CITY OF AUSTIN – DEVELOPMENT SERVICES DEPARTMENT
SITE PLAN APPLICATION – MASTER COMMENT REPORT

CASE NUMBER: SP-2020-1025C
REVISION #: 0
CASE MANAGER: Clarissa E. Davis
UPDATE: U0
PHONE #: 512-974-1423

PROJECT NAME: BOAT DOCK & BULKHEAD
LOCATION: 3002 SCENIC DR

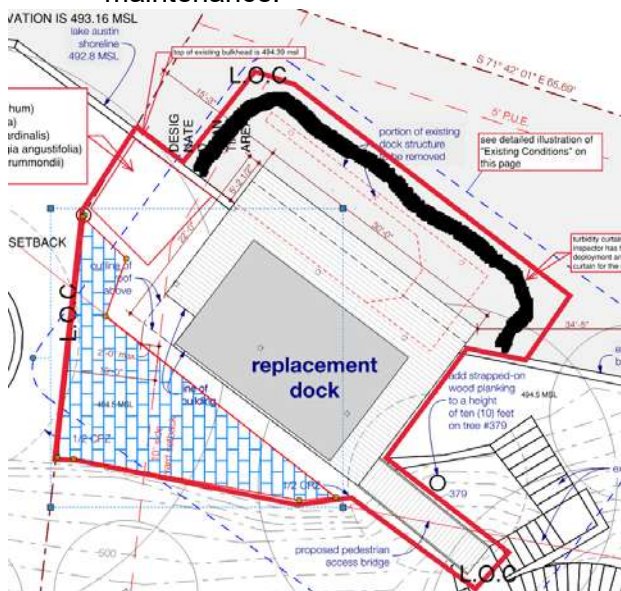
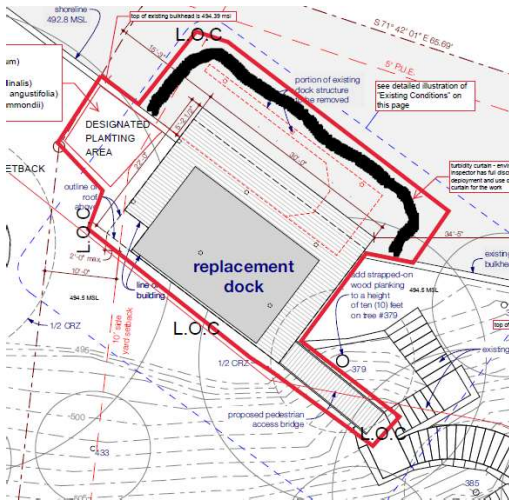
EV 8 On the ESC sheet, hatch the area where the LOC enters into the CWQZ.

Update 1 Comment not cleared.

1. Explain what work is proposed in the blue hatched area. If no work is proposed, remove this area from the LOC.
2. If work is proposed and the area stays in the LOC, hatch the area and add a callout note stating: "This area requires native grassland seeding and planting per City of Austin Standard Specification 609S.6, including topsoil and seed bed preparation, temporary irrigation, and weed maintenance."

Agent Reply EV8 > Please see the revised LOC which excludes the "blue hatched area".
